May 2019
FL788A-O
NHTSA #18V-582
Transport Canada #2018-468
REVISED NOTICE

Subject: FCCC Motorhome Chassis Rear PDMs

Models Affected: Specific Freightliner Custom Chassis X-Line chassis manufactured November 23, 2015, through June 29, 2018, and equipped with a certain PDM.

Fig. 2, PDM Components

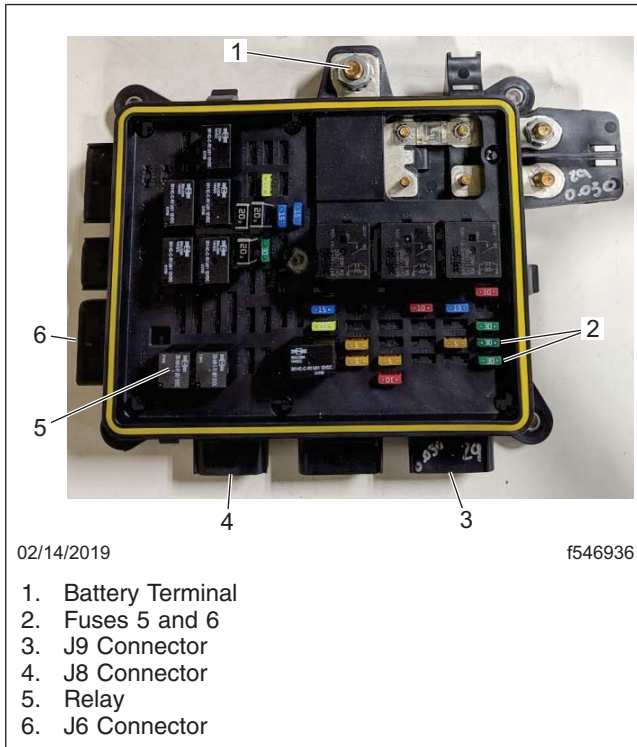
REVISIONS: The NHTSA number has been corrected to 18V-582, and the work instructions have been updated. On step 8 of the work instructions the probe locations have been corrected from F6 & F7 to F5 & F6 as well as fig. 2 has been updated to match the correct locations.

REVISIONS: The NHTSA number has been corrected to 18V-582, and the work instructions have been updated. On step 8 of the work instructions the probe locations have been corrected from F6 & F7 to F5 & F6 as well as fig. 2 has been updated to match the correct locations.
